Access Compliance Report

Public Rights-of-Way

Intersection ID: 14946	Main Street: DILWORTH_RD_WEST	Cross Street: E WORTHINGTON AV	Location: S
ADA ID: 17DA383E0067	Ramp Type: Perp	Initial Pass/Fail: Fail	Overall Compliance: No
		Severity Score: 8.75

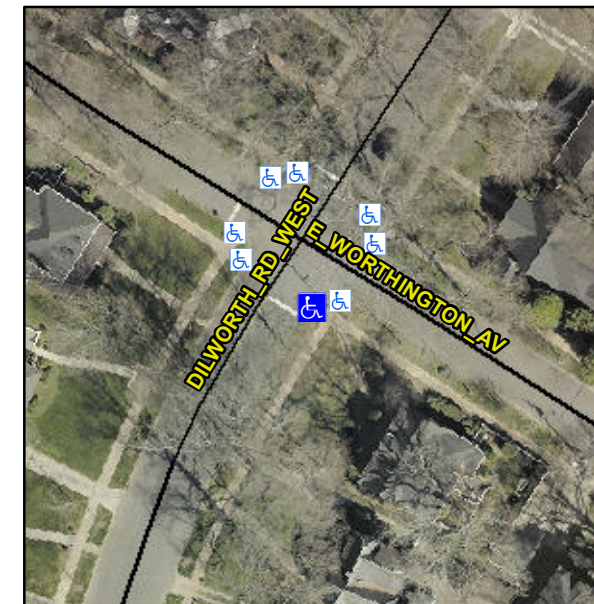
Not Found, R304.5.1

Compliance	Description	Data	Compliance	Description	Data
N/A	Ramp Length (in)	51.0	Yes	Ramp Slope (%)	8.3
No	Ramp Width (in)	36.0	Yes	Ramp XSlope (%)	2.0
N/A	Flare Type LT	N/A	N/A	Flare Type RT	N/A
N/A	Flare Slope LT (%)	N/A	N/A	Flare Slope RT (%)	N/A
N/A	Flare Traversable LT?	N/A	N/A	Flare Traversable RT?	N/A
N/A	Landing Length (in)	N/A	N/A	DWS Provided?	N/A
N/A	Landing Width (in)	N/A	N/A	DWS Contrast?	N/A
N/A	Landing Slope (%)	N/A	N/A	DWS Length (in)	N/A
N/A	Landing X Slope (%)	N/A	N/A	DWS Full Width?	N/A
N/A	Landing Curb? (Y/N)	N/A	N/A	DWS Offset (in)	N/A
N/A	Shared Landing?	N/A			
N/A	Gutter Ponding?	Yes	N/A	Gutter Slope (%)	N/A
N/A	Gutter Lip Ht (in)	N/A	N/A	Gutter X Slope (%)	N/A
N/A	Painted X Walk1?	No	N/A	Painted X Walk2?	N/A
	X Walk 1 Direction	To NW		X Walk 2 Direction	N/A
N/A	X Walk 1 Width (in)	N/A	N/A	X Walk 2 Width (in)	N/A
	X Walk 1 Slope (%)	4.0		X Walk 2 Slope (%)	N/A
	X Walk 1 X Slope (%)	1.2		X Walk 2 X Slope (%)	N/A

Remove & Replace Entire Ramp.
